SUB-DIVISION OF HOUSE SITES IN T.S.No: 1(OLD S.Nos.90/1pt, 90/2, 91, 118/1A1pt 119/1A1, 127/1B & 11) BLOCK NO. 1, WARD - H OF SEMMANCHERI VILLAGE.

P.P.D NO : **242**
L.O **2023**
APPROVED
VIDE LETTER NO : LAYOUT-1 / 0029 / 2023
DATE : 25 / 09 / 2023

OFFICE COPY
FOR MEMBER SECRETARY
CHENNAI METROPOLITAN
DEVELOPMENT AUTHORITY

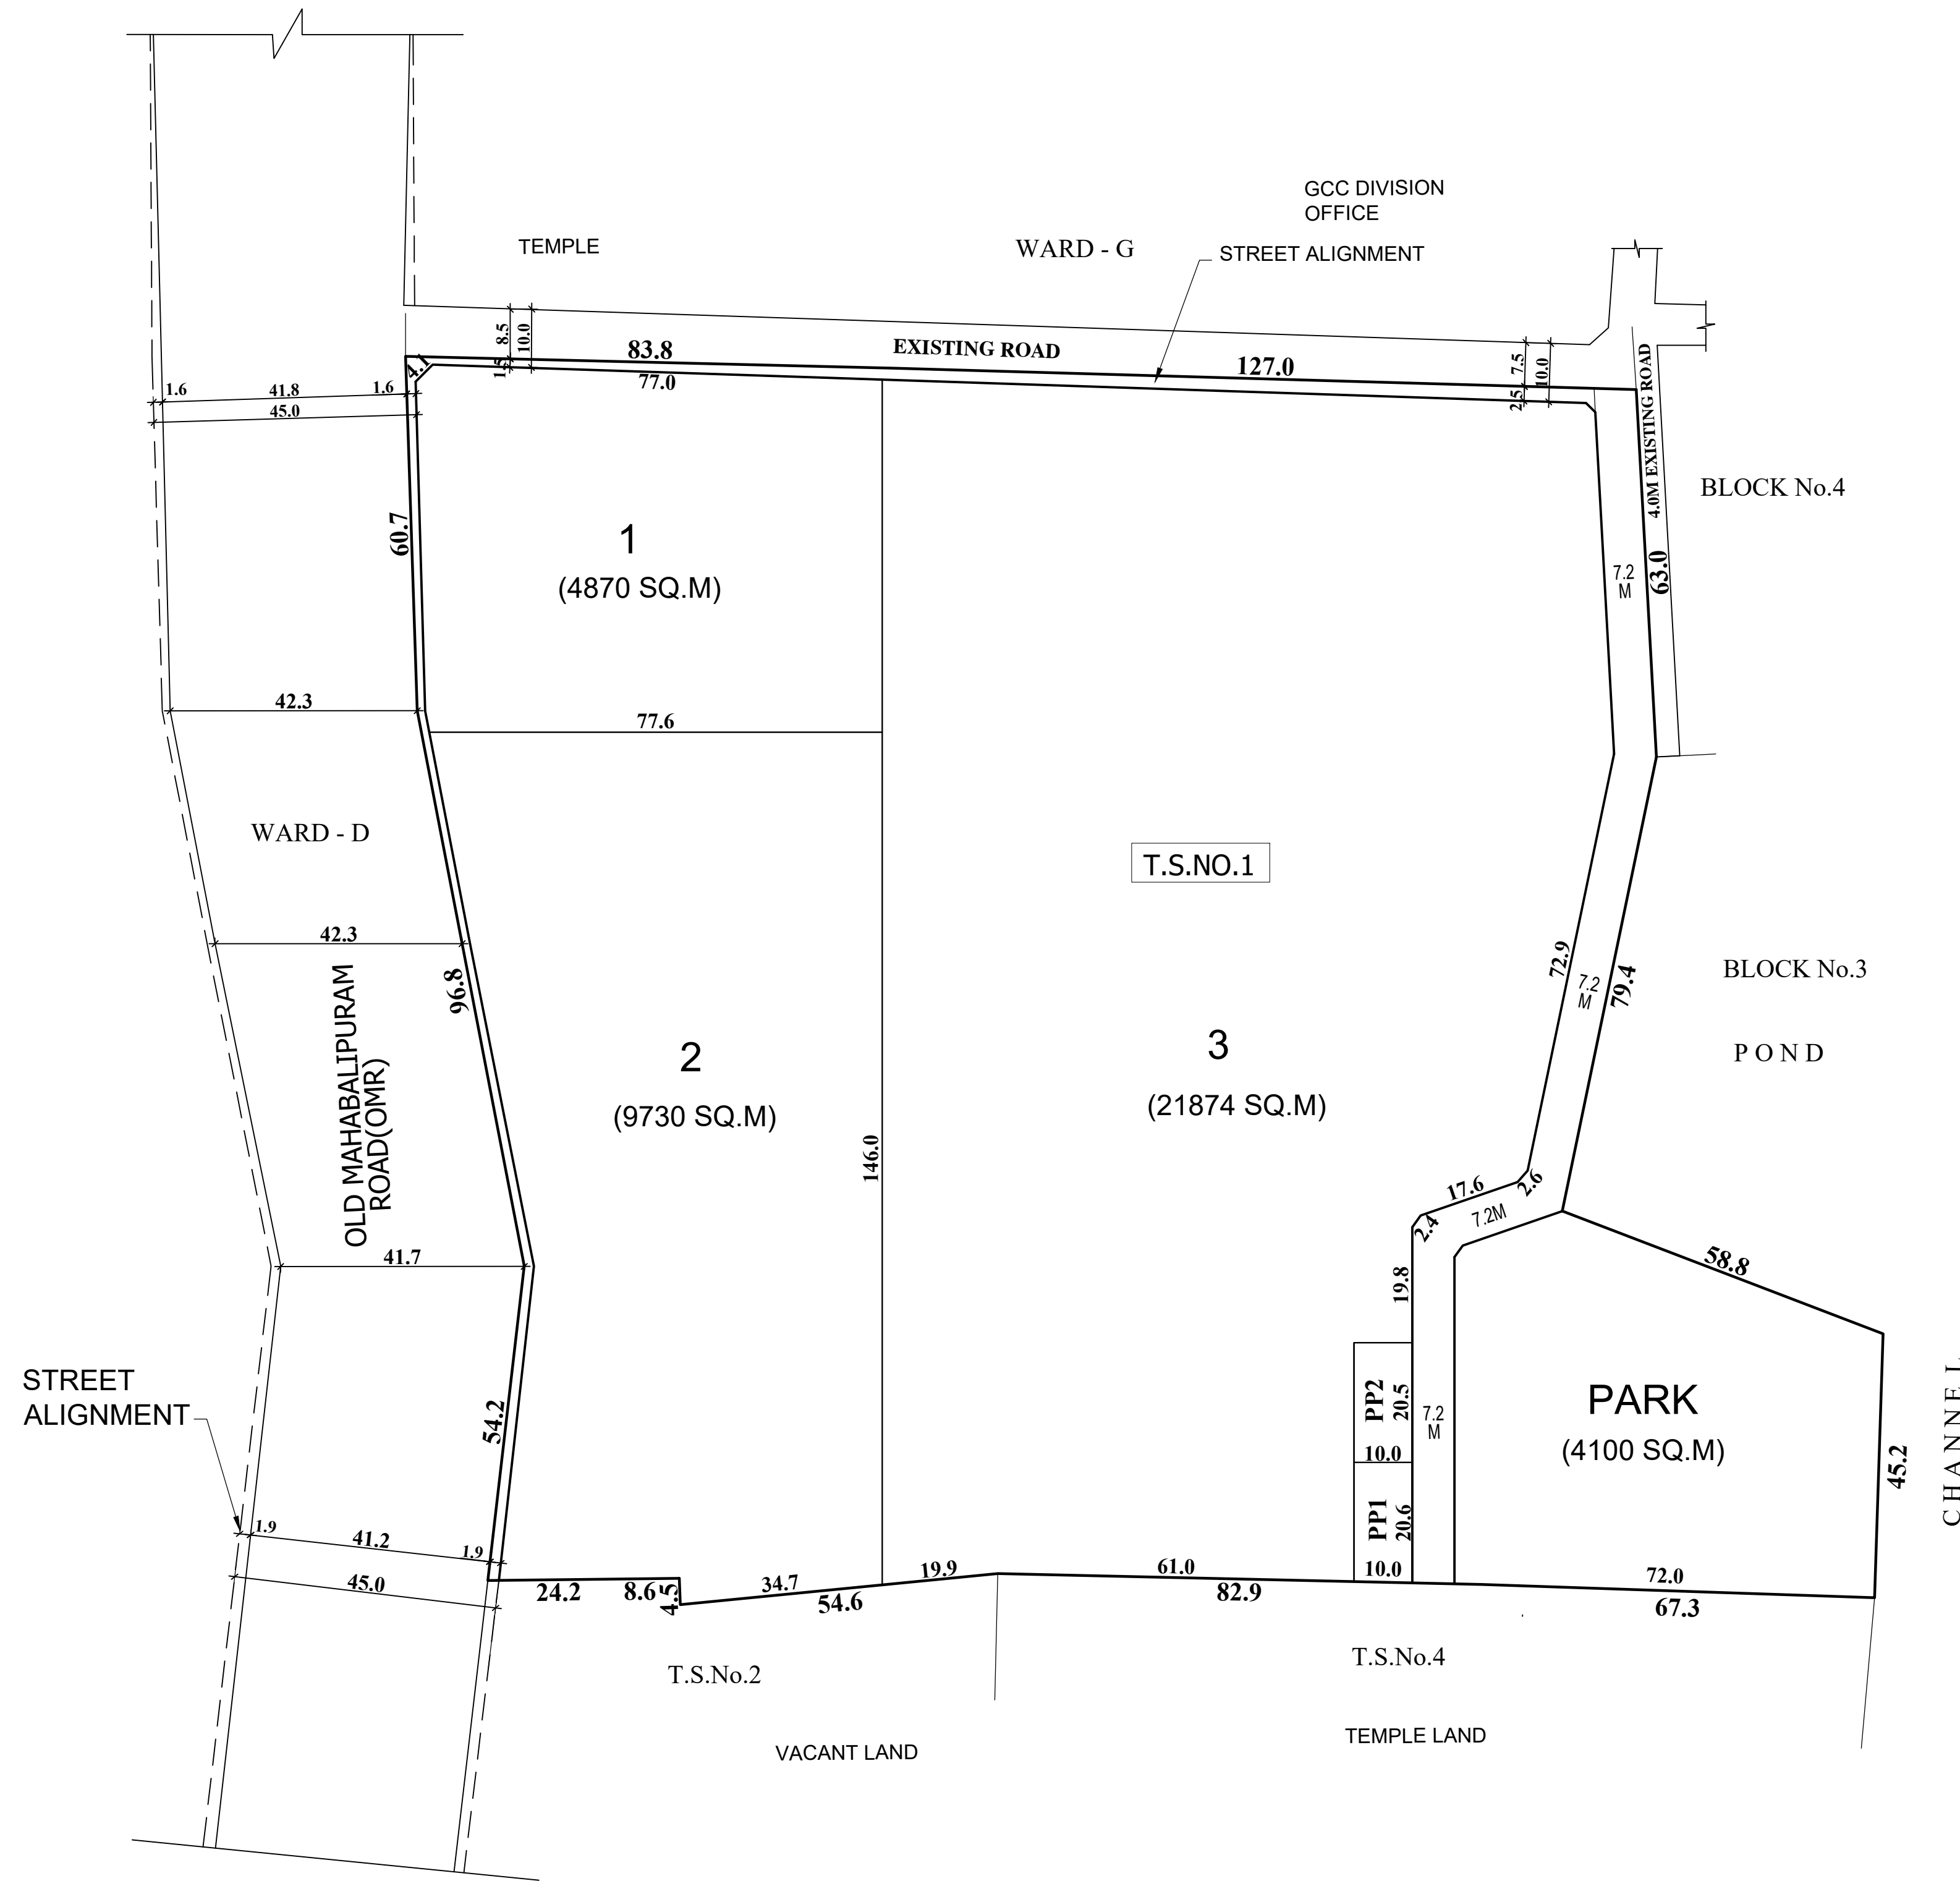
- The applicants' land should be filled with earth filling with proper compaction to the minimum level of (+)11.050m (i.e.,) 0.820m above Crest level of the Semmancheri Rettai Kutai Thangal (+)10.230m. To protect the site from inundation during floods. The process of earth filling and compaction should be done in layers of not more than 0.30metre depth to achieve required degree of compaction for the depth from (+)1.170m to (+)1.870m depending upon the existing field levels. Also, the applicants should provide emergency pumping operation for the sewage water, if it is proposed to have basement floor and as well as dewatering arrangements during flood periods. The all-round pavement level within the site should not be less than (+)11.050m and the regular habitation should not be below MFL.

- The Government Thangal in SF.No.113 & Kutai in SF.No.92 of Semmancheri village abutting on Eastern side the applicant boundary should be marked as per FMB and monitored and maintained by the applicant at his own cost. The width of the River/Eri/Thangal/Channel should be maintained without encroachments as per Revenue records and the hydraulic parameters of the field River/Eri/Thangal/Channel should be maintained.

a. The applicant should prepare the layout proposal by considering the suitable internal storm water drainage network drains i.e., peripheral drain of size 0.90m x 0.60m and lateral drain of suitable size as per prevailing site conditions. The same should be connected to the local drain/channel, rainwater harvesting and sewerage treatment and its disposal and garbages/debris and other solid waste management as per norms in existence within the applicant's land according to existing rules in force and should get proper approval from competent authority without fail.

b. The necessary setback distance (i.e., 3.0m especially on Eastern side) should be provided with in the site as per site condition as per the norms in existence and as per the rules in force of CMDA (as per the circular issued by the office of the Commissioner of Town & Country Planning, Chennai - 2 vide Roc. No. 4367 / 2019-BA2 / Dated: 13.03.2019) during development and there should not be any construction activities in the future also, the CMDA should issue completion certificate only after obtaining compliance certificate NOC from WRD.

In order to ascertain the gravity of inundation of the said lands, the field levels were taken with reference to the Bench Mark from the Crest level of the Semmancheri Rettai Kutai Thangal (+)10.230m. The Full Tank Level (FTL) and Maximum Water Level (MWL) of the Rettaikutai Thangal Tank (S.F.No.1262) is (+)10.230m & (+)10.440m. It could be susceptible against inundation potential must be ascertained based upon the existing filed levels. As a safety measure, the proposal site must be analysed with respect to the flood levels experienced during previous catastrophic floods. The observed Maximum Flood Level during 2015 floods is (+)10.440m and the Old Mahabalipuram Road (OMR) is (+)10.450m on Western side. To protect the site safe against any inundation in the near future, the site must be raised to a minimum level of 0.60m above the MFL (or) road top level abating / nearer to the site. Whichever is higher, here Road level is higher than MFL. Hence it is recommended to raise the existing field to a minimum level of (+)10.450m+0.60m (+)11.050m (i.e.,) 0.820m above Crest level of the Semmancheri Rettai Kutai Thangal (+)10.230m.

Also, the proposed land is to be raised (+)1.170m to (+)1.870m with hard earth with proper consolidation to avoid inundation problem during rainy season from the above existing field levels, the required filling varies from (+)1.170m to (+)1.870m to avoid inundation. Since the existing field level of the site is below MFL.
